## ST. TAMMANY PARISH

**Addendum No.:**4

**Bid#:** 24-62-2

**Project Name:** Cross Gates Wastewater Treatment Plant Improvements

SHEET NO.  
G-5

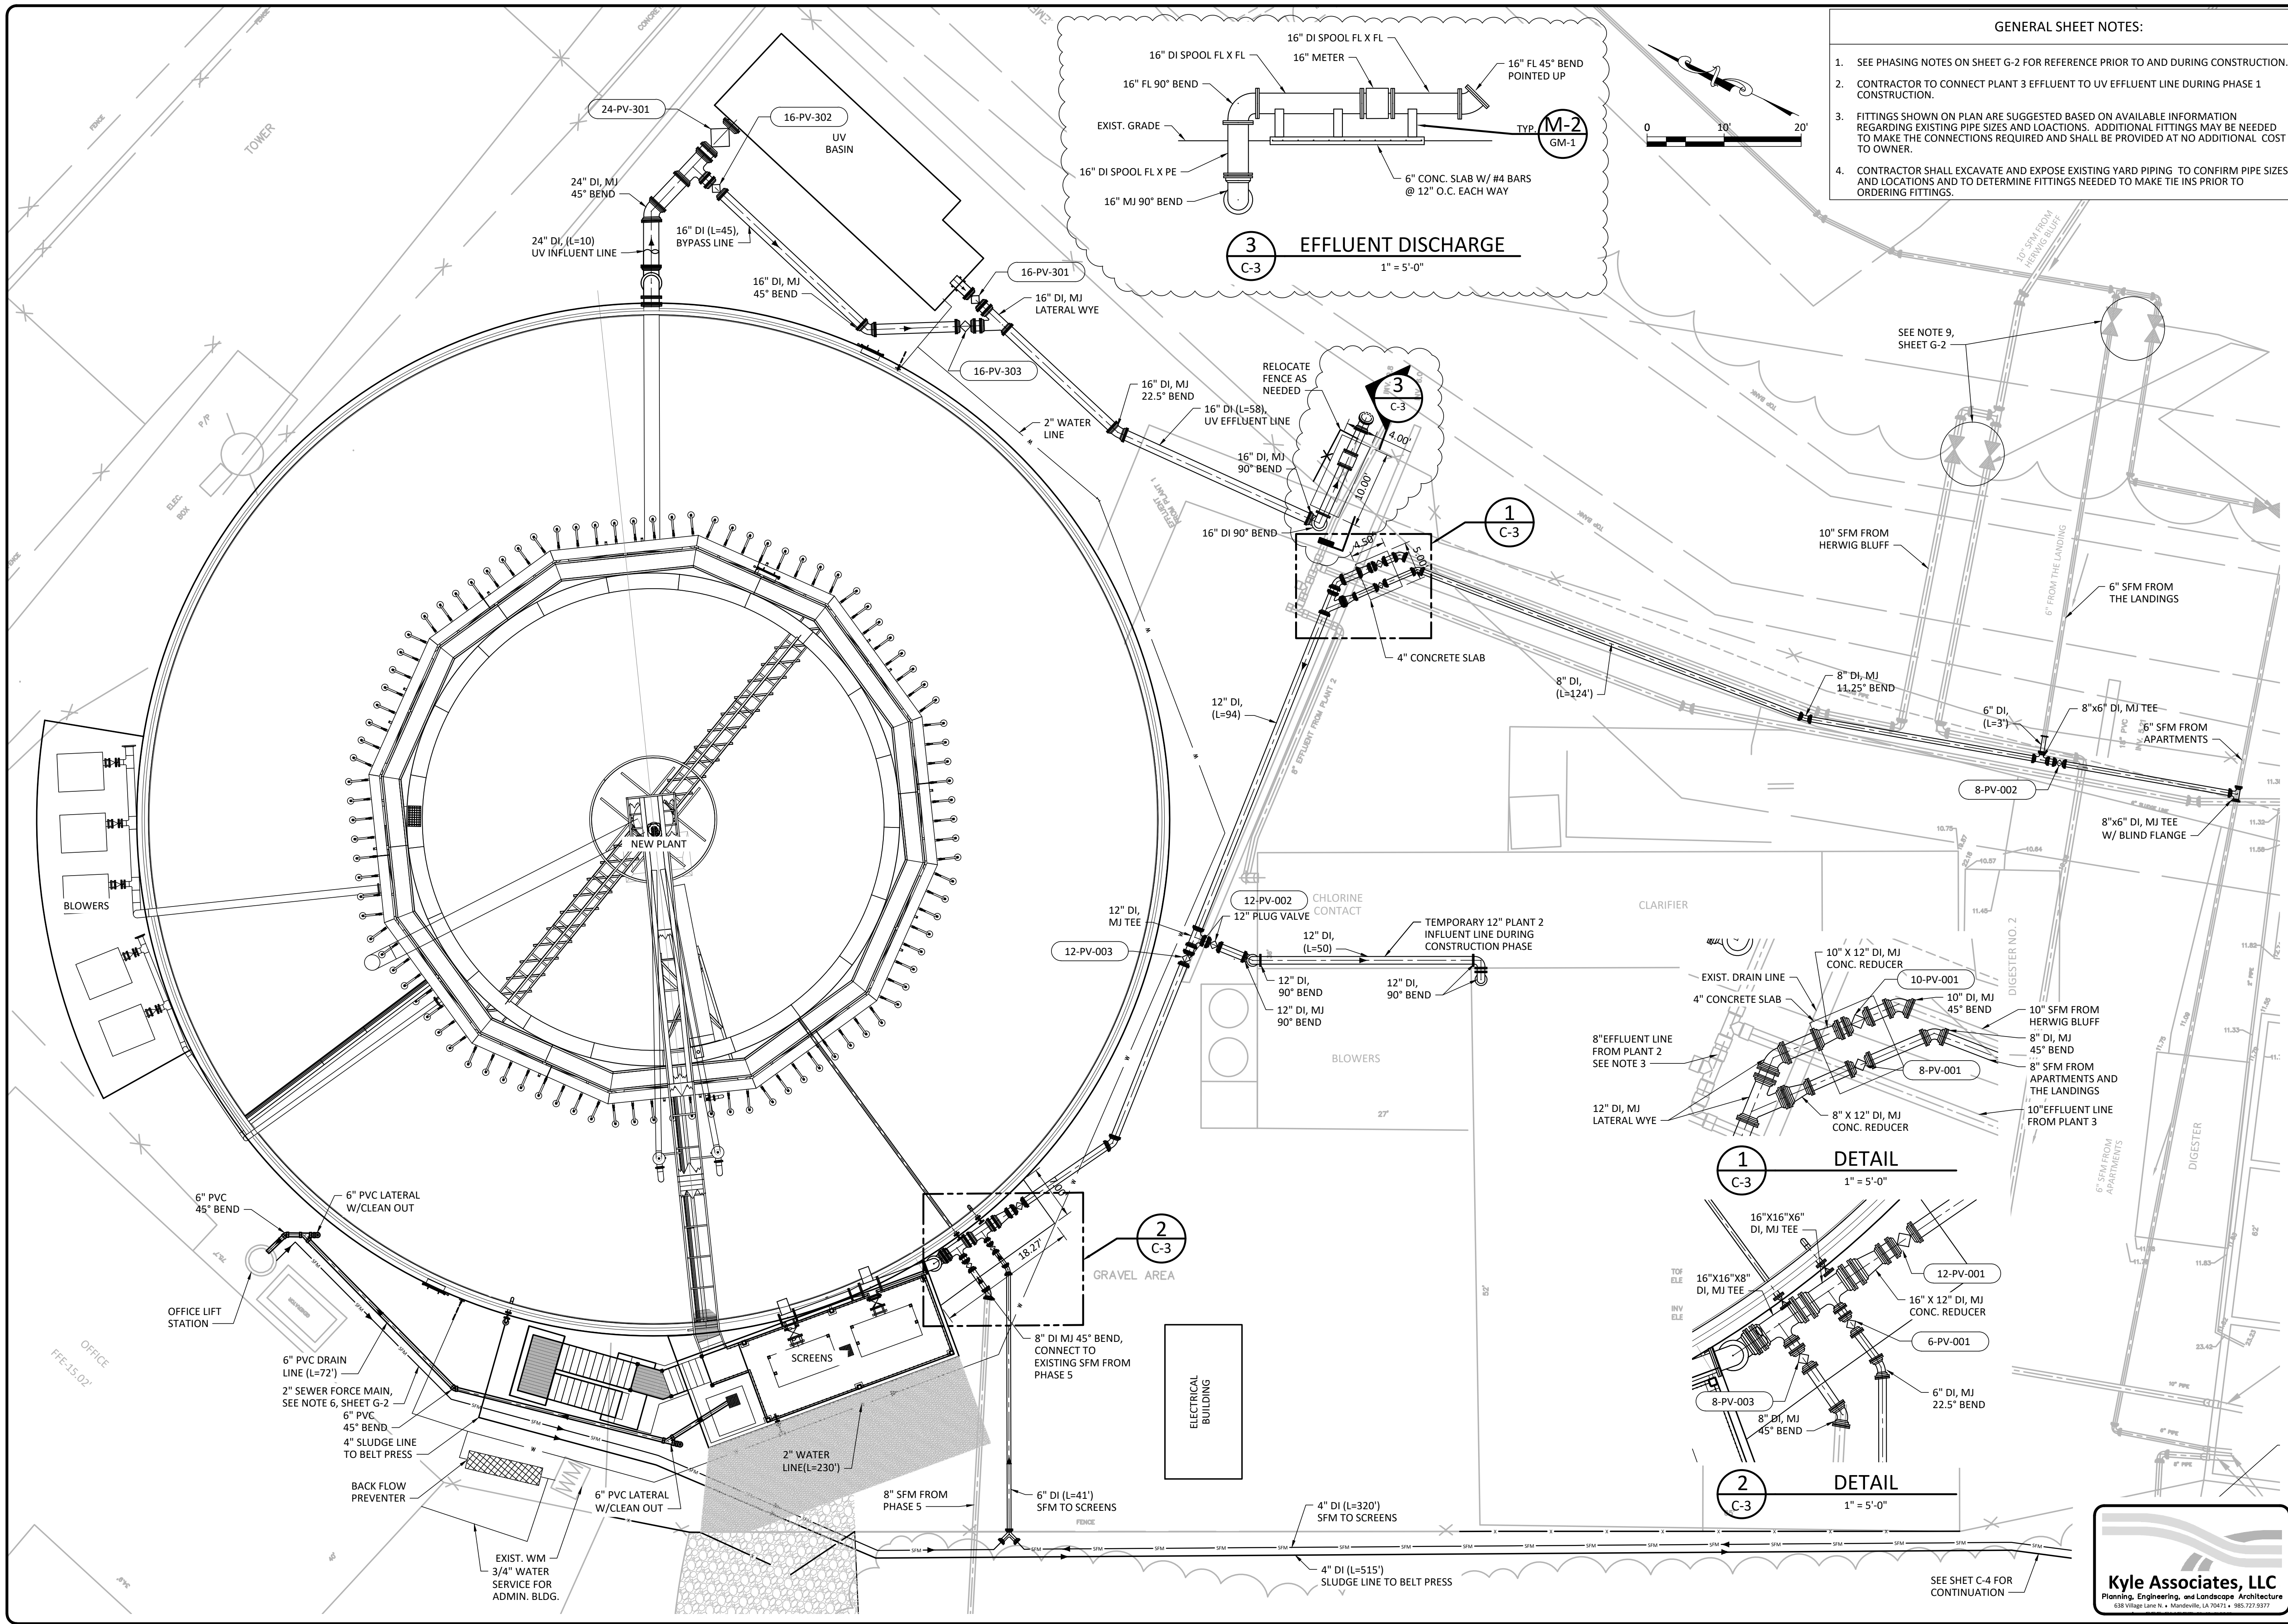
QUESTION 7: Sheet G-5 Process Flow Diagram – the flow diagram shows a separate sludge pump station for WAS between the new plant and the belt press. Where is that intended to be? Is that included in the plans?

ANSWER 7: There is no sludge pump station. It has been removed from Sheet G-5.

SHEET NO.  
**C-3**

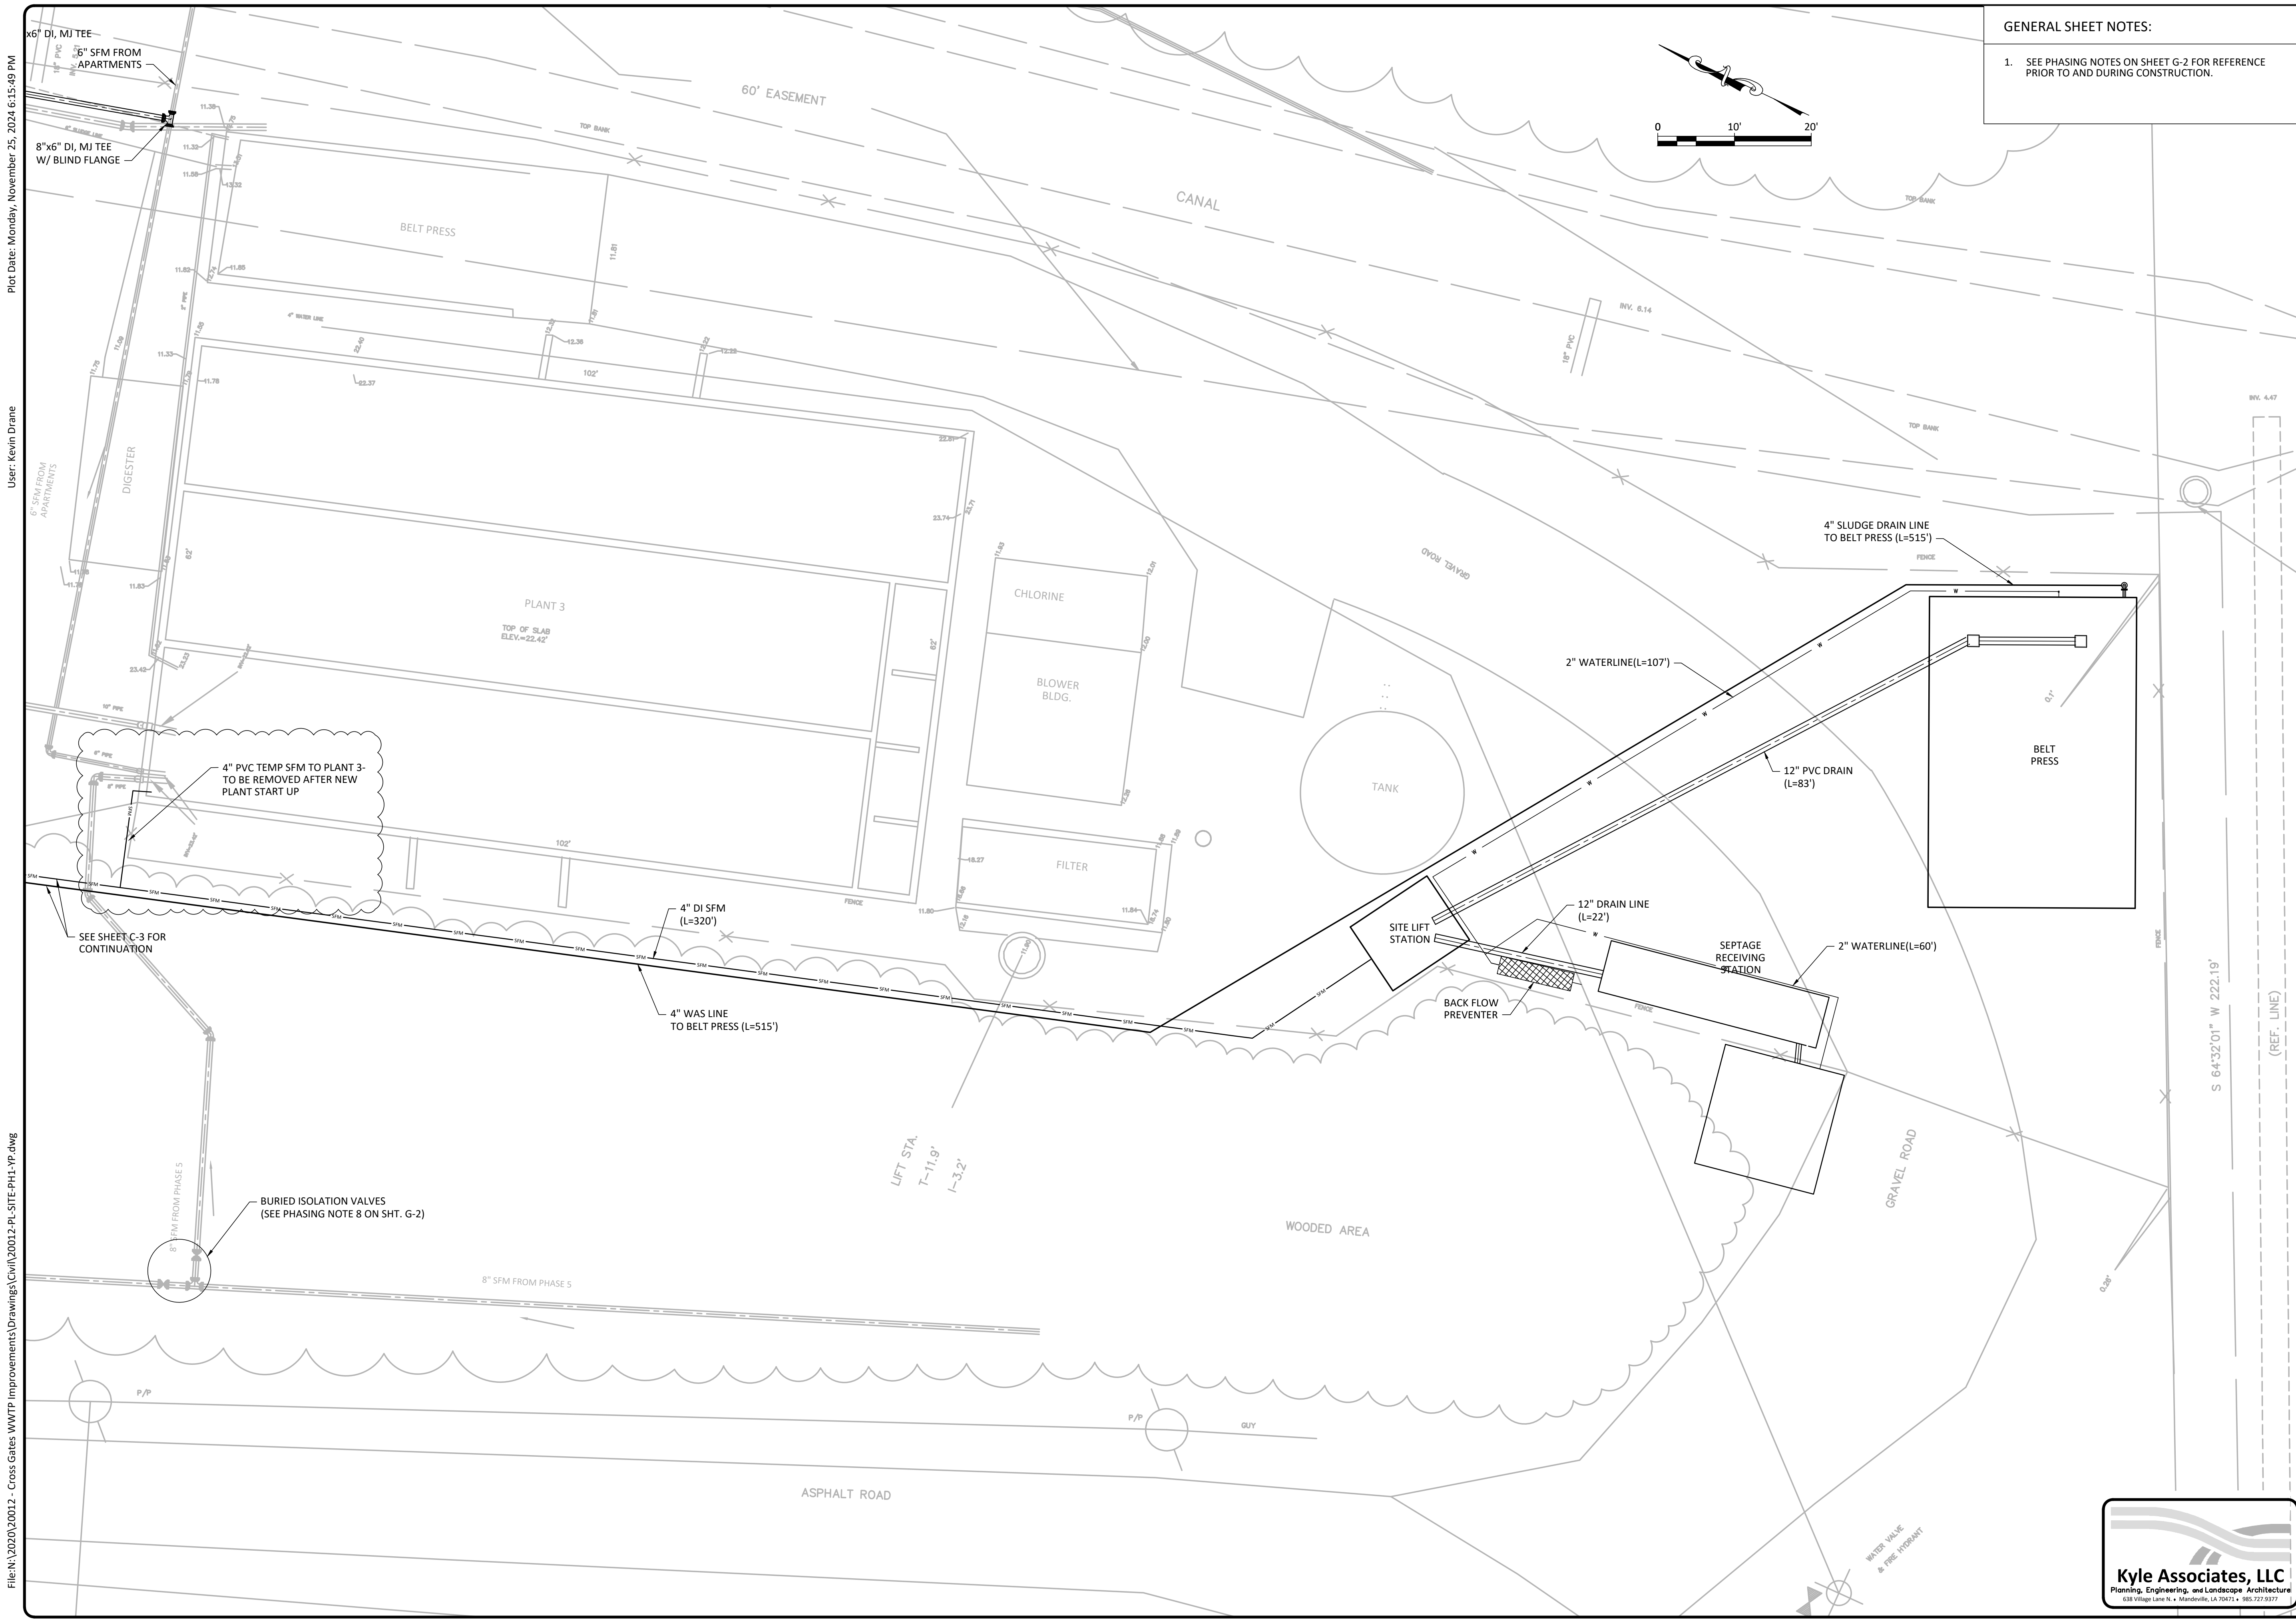
QUESTION 3: Sheet C-3 general note 2 - is that note correct or should that read Plant 1? Routing from Plant 3 is unclear.

ANSWER 3: The effluent line from Plant 3 will remain connected to the existing plant discharge line throughout construction.

SHEET NO.  
 C-4

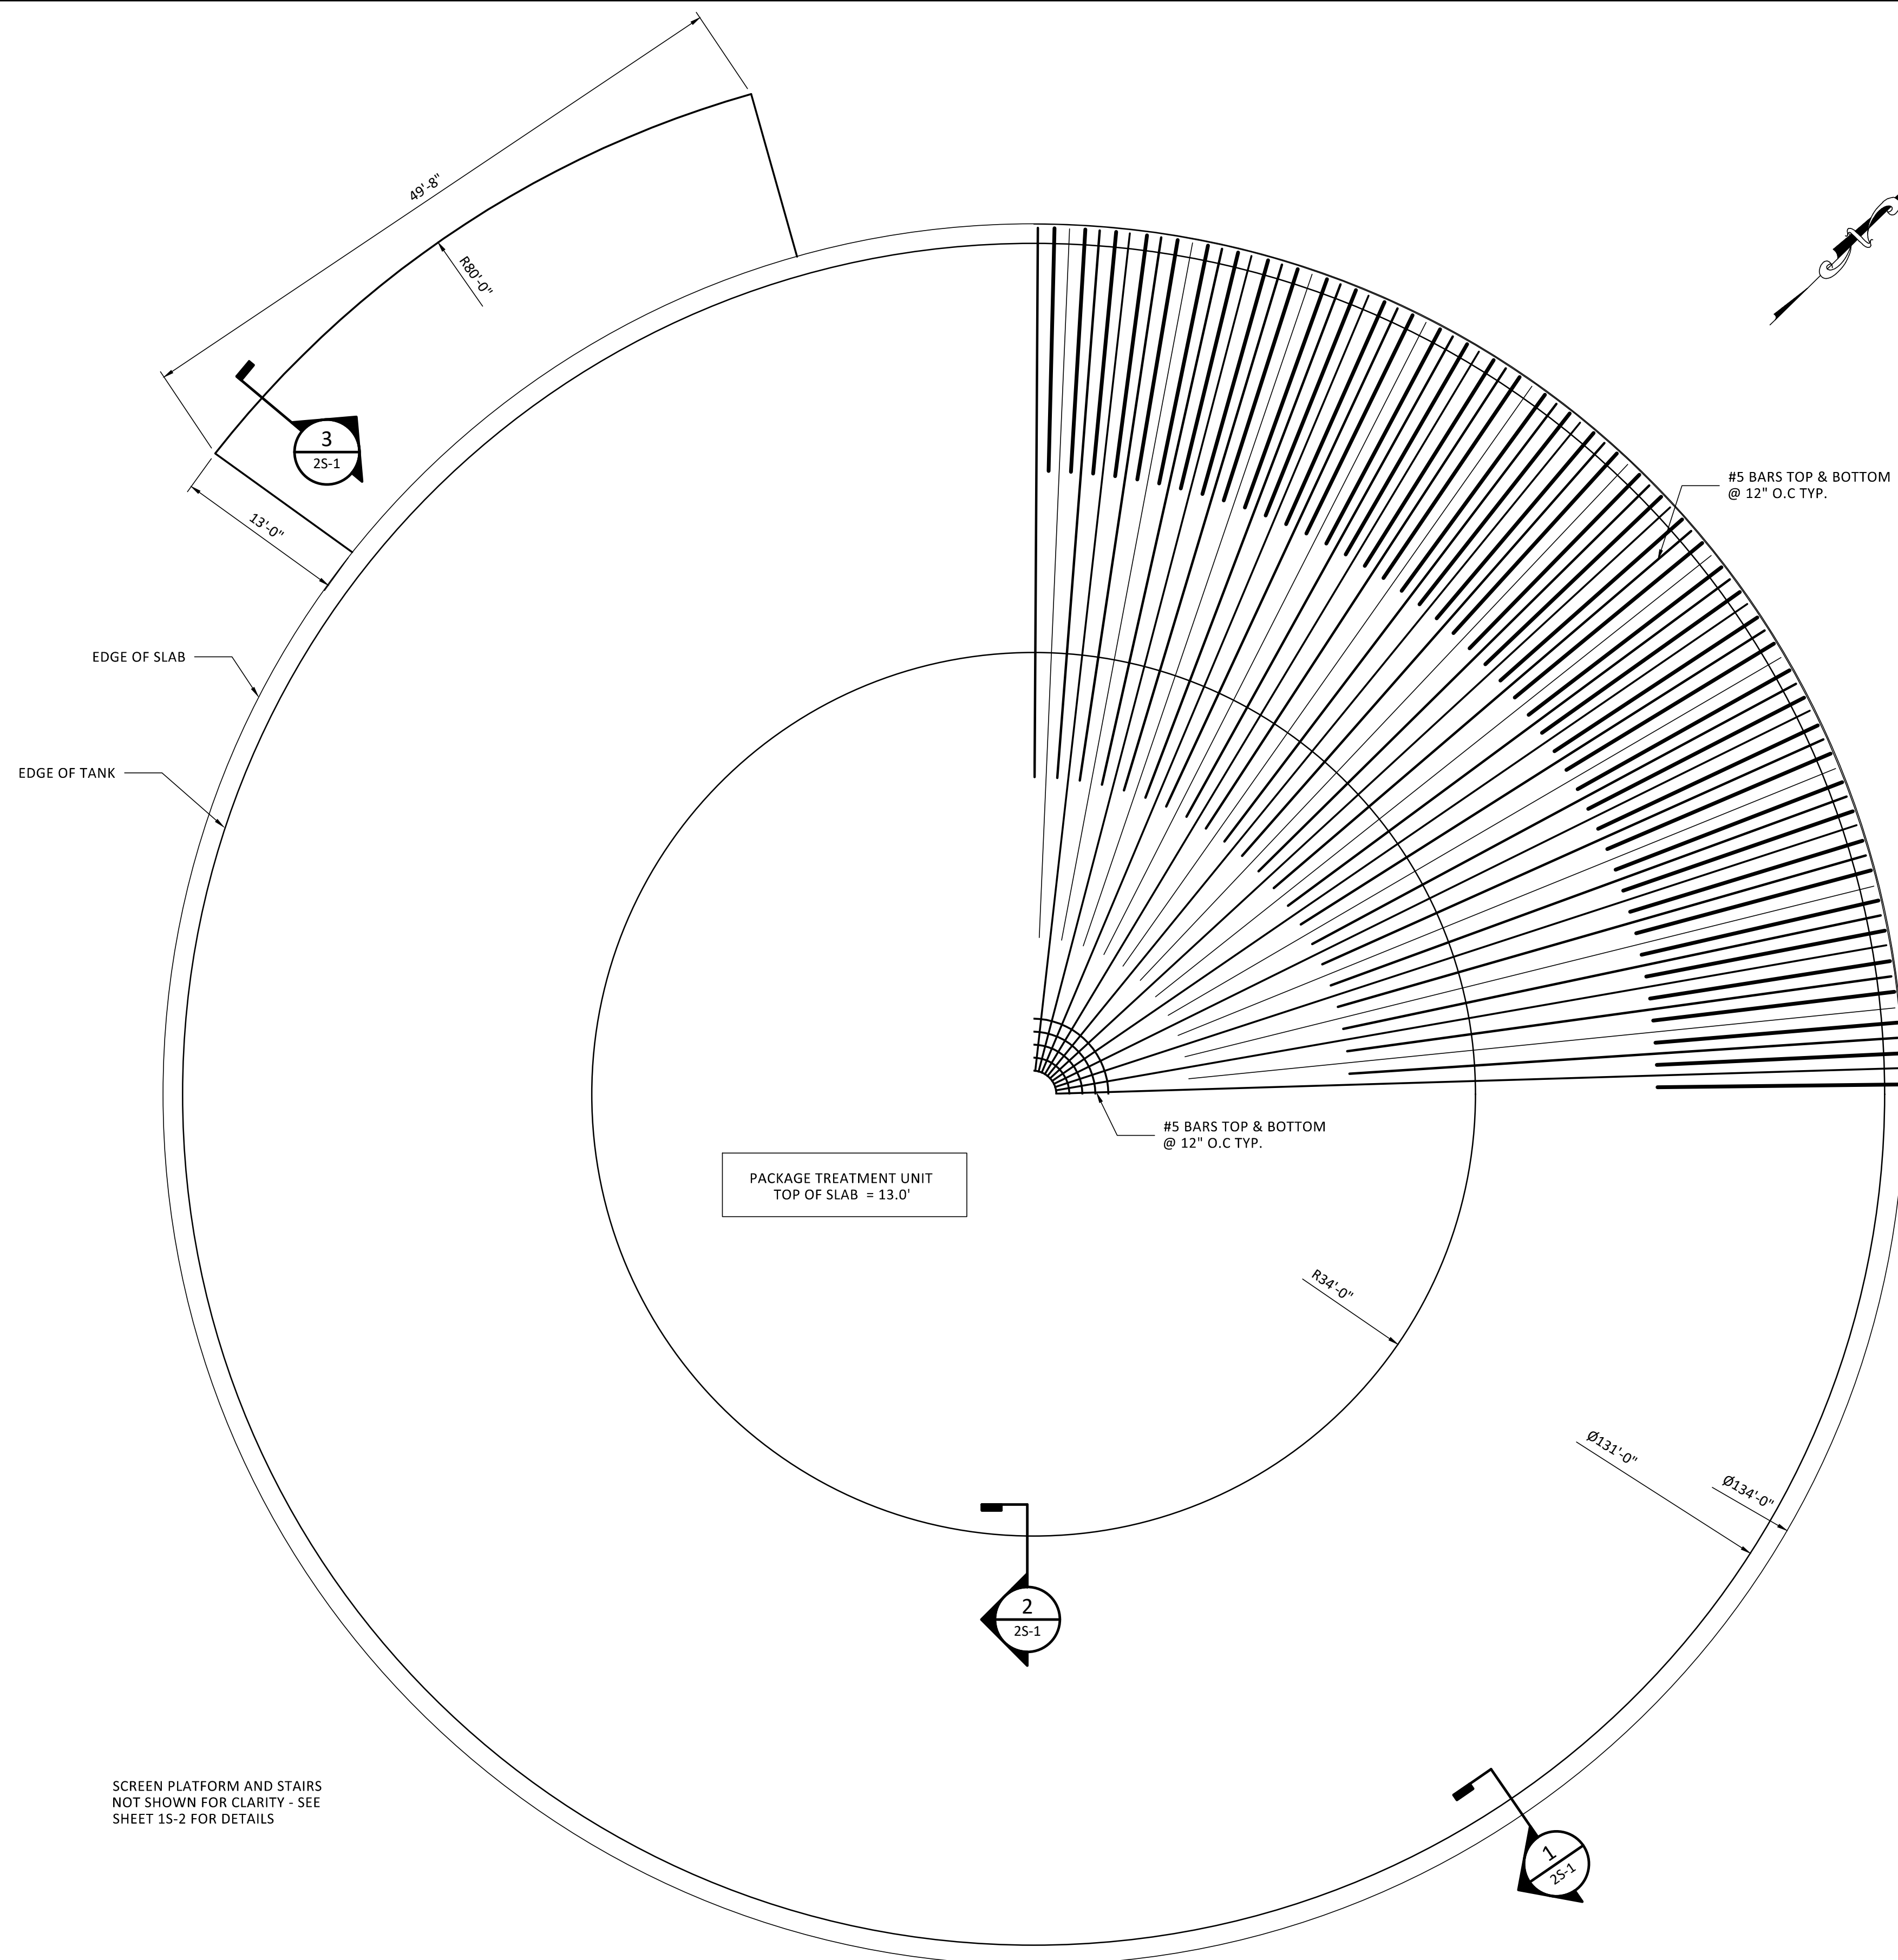
QUESTION 4: Sheet G-2 phasing note 7 – SFM line from Site Lift Station - plans show that being pumped to Plant 2. Is that note correct, Routing to Plant 3 is unclear.

ANSWER 4: The note is correct as written, but it has been revised to clarify. Sheet C-4 has been revised to show the connection to Plant 3.
